TO: Historic Landmarks Commission

CASE NO.: Historic Design Review Case No. HIS24-23

APPLICATION SUMMARY: A proposal to construct a new residence to replace one destroyed by fire.

LOCATION: 1598 Court Street NE

SITE PLAN
1598 COURT ST. NE.
SALEM, OR 97301
SCALE: 1" = 20.00'

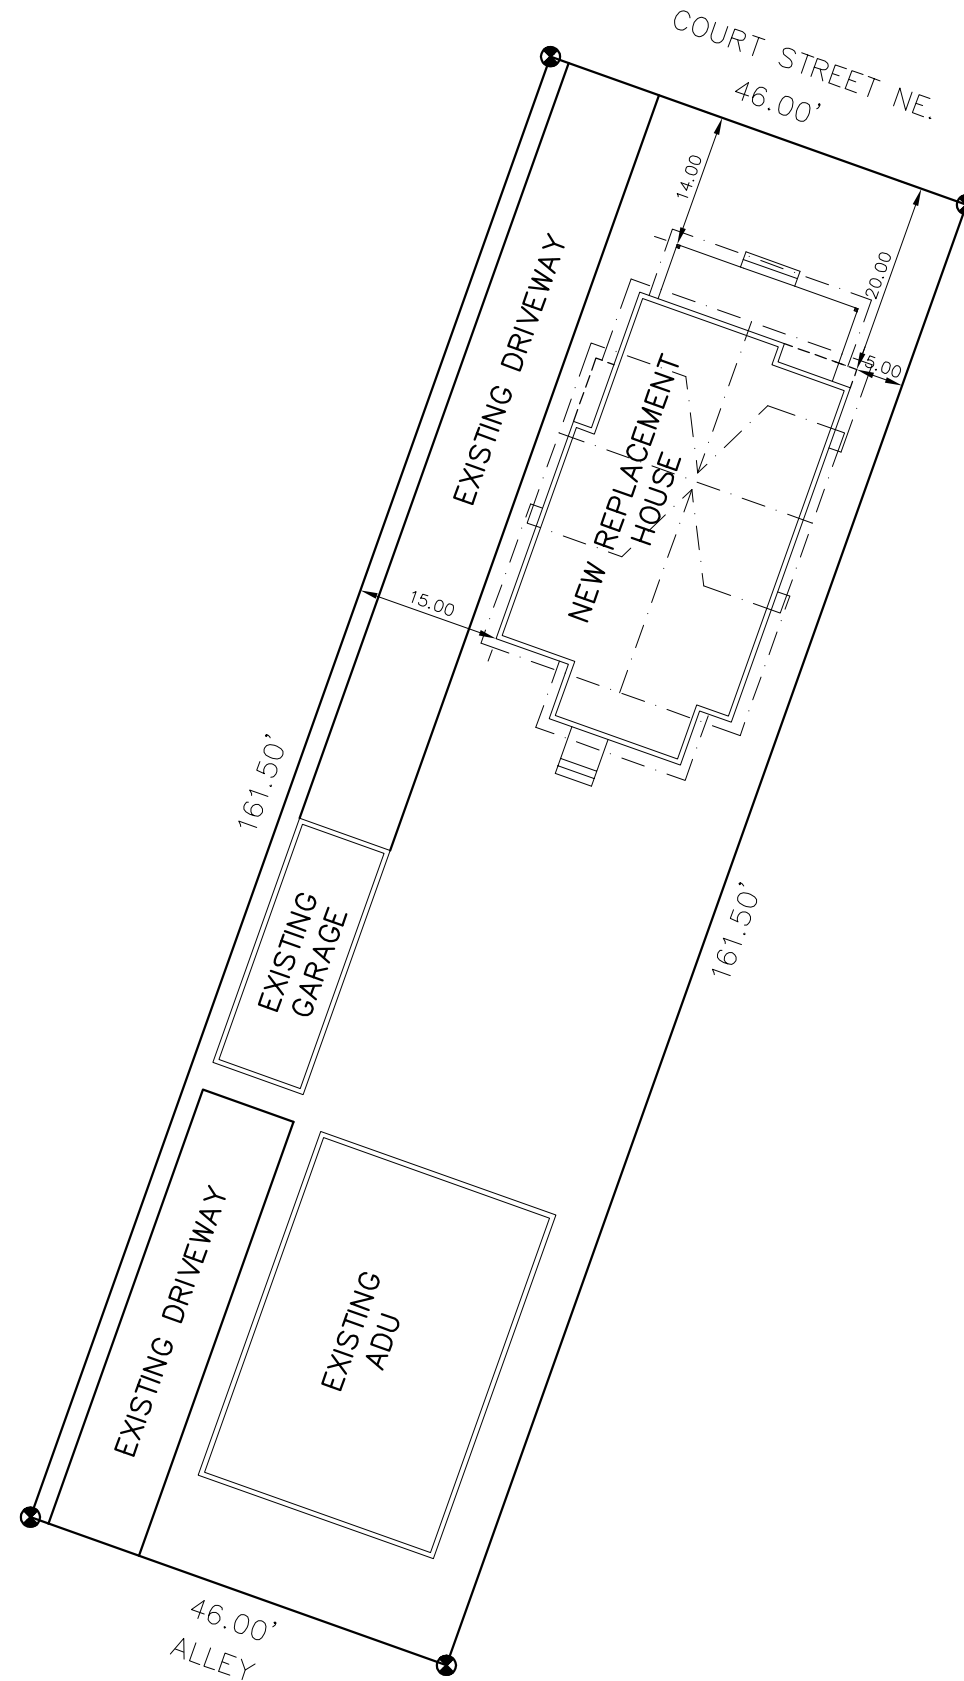
Finding: The proposed house faces Court Street and is centered on the lot between an existing driveway and set-back 5 feet from the neighboring lot on the east. The front of the house, including the front porch, is set-back 14 feet from the right-of-way, similar to the lot placement of historic buildings in the vicinity. Additionally, the placement of the house in the same location to the previous one restores the property's historic spatial relationship between primary house and historic cottage. Therefore, Staff recommends that the HLC find that SRC 230.035(b)(1)(G) is met.

FRONT ELEVATION SCALE: 1/4" = 1'-0"

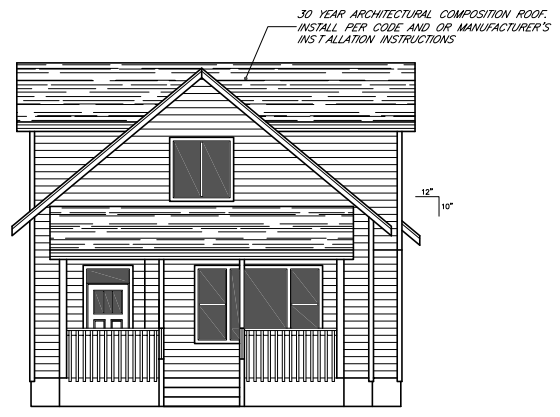
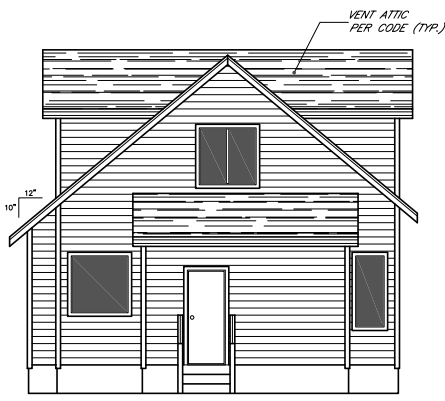
Finding: The proposed design has a covered front porch leading to the front door with a large front window next to it. There is a single front dormer in the roof above. The combination of these elements creates a front entrance design that appears symmetrical, balanced is similar to those on existing historic houses in the district. The front stairs are centered on the porch, which is relatively common. Therefore staff recommends that HLC find that SRC 230.035(b)(1)(E) has been met.

Finding: At two stories in height, the proposed house is of a pedestrian scale. The covered front porch brings proportion and balance to the overall approach to the front entrance of the home. The balanced design of the porch, front door and front window, as well as the upper centered dormer window bring a proportion to the home that is comfortable and fits in with the scale and proportions of surrounding homes. Like many neighboring homes in the district, it is three steps up the covered porch in order to approach the front door. Therefore, staff recommends that the HLC find that SRC 230.035(b)(1)(F) has been met.
